**DEFENSE NUCLEAR FACILITIES
SAFETY BOARD**

Summary of the Underground Ventilation System Project and Related Observations

Project Summary. On December 23, 2015, the Department of Energy (DOE) approved the Critical Decision (CD)-1, *Approve Alternative Selection and Cost Range*, milestone for the Underground Ventilation System (UVS) Project at the Waste Isolation Pilot Plant (WIPP). The UVS will play a critical role in restoring WIPP to an operational status necessary for DOE to meet its legislative and regulatory requirements for transuranic waste disposition. At CD-1, DOE has elected to proceed with a design alternative that provides a new unfiltered exhaust shaft for mining operations and uses the existing exhaust shaft with additional high-efficiency particulate air (HEPA) filtration capacity for waste disposal operations. The anticipated safety classification of the UVS is safety significant.

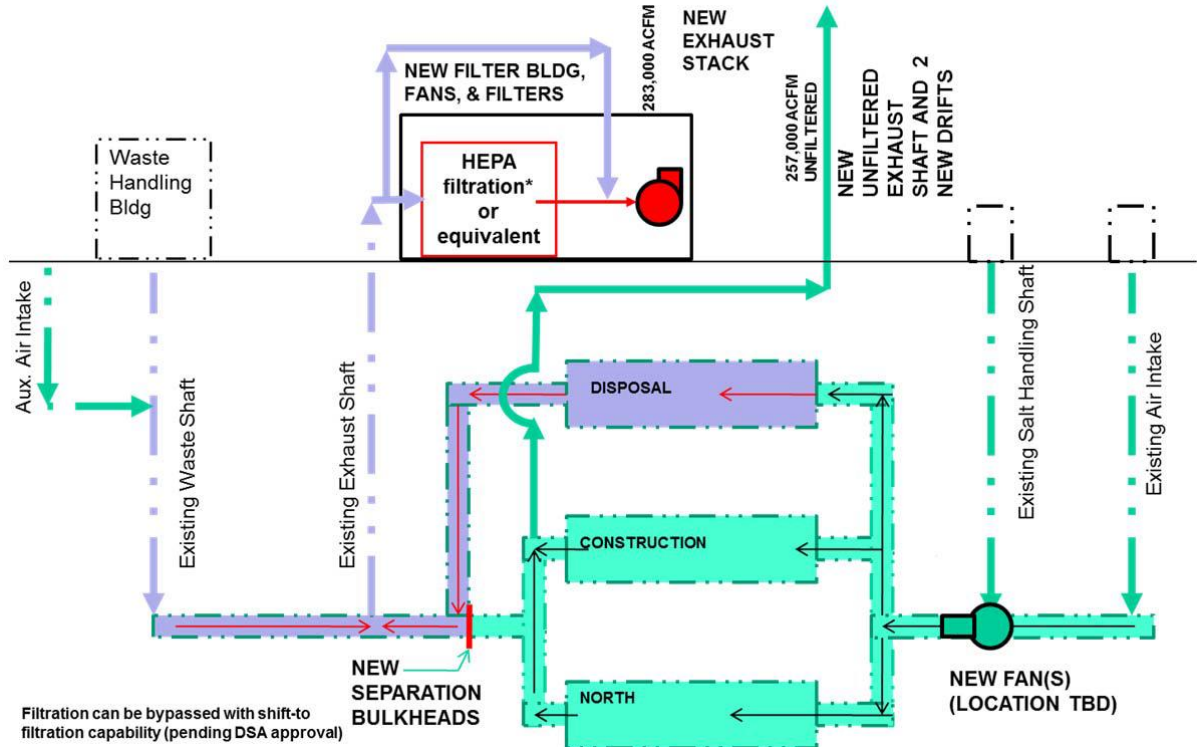
Confinement Strategy Observations—The Board’s review team identified a concern regarding potential reliability issues of the bypass switch to confinement capability on the detection of airborne radioactive material in the potentially contaminated zone. The CSDR identifies the potential for re-suspension of contaminated salts in the existing exhaust shaft and

- Ensuring that CAMs can reliably detect airborne radioactive contaminants while operating in a high airborne particulate environment. These airborne particulates could be the result of routine operations or from fire or other accident scenarios.

- Defining the number and locations of CAMs emplaced throughout the underground may be a complex task. Project documents note that existing drifts and exhaust shaft have the potential for renewed suspension of radioactive material released by the February 14, 2014, event. The location of both the source of the re-suspended radiological material and the CAM that detects the airborne contamination could challenge the expected response times for the UVS to switch from the bypass to filtered mode of operation.

- Qualifying and testing bypass isolation dampers that would be integral to directing flow to the HEPA filters in the event of an airborne release of radioactive contaminants in the underground. The effectiveness of the HEPA filters could be diminished if the high dust and salt content in the exhaust air compromise the sealing capability of the bypass dampers.

Project personnel stated that the reason for including the bypass function was to reduce the frequency of filter changes. While this may be an advantage from an operational efficiency perspective, it comes with the need to employ components to actuate the safety significant UVS HEPA filtration function. Among the safety design guiding-principles in DOE Standard 1189-2008 is the preference of passive SSCs over active SSCs in formulating the control selection strategy to address hazardous material release events. While an active confinement ventilation

Project personnel confirmed that meeting the necessary functional and performance requirements commensurate with safety significant structures, systems, and components (SSCs) related to the bypass function will be further evaluated early in the preliminary design phase of the project. Based on the challenging environmental conditions and past performance of the WIPP CAMs and dampers, the Board's staff believes that testing and qualification of these systems to determine if they can meet their safety functions when called upon might require a technology readiness assessment prior to upcoming CD milestones. DOE currently requires that technology readiness level 7 be achieved at CD-2. The next major milestone is a combined CD-2/3 in fiscal year 2017. If the bypass function is found to be infeasible, project personnel indicated that waste disposal operations will be subject to full-time active confinement ventilation.
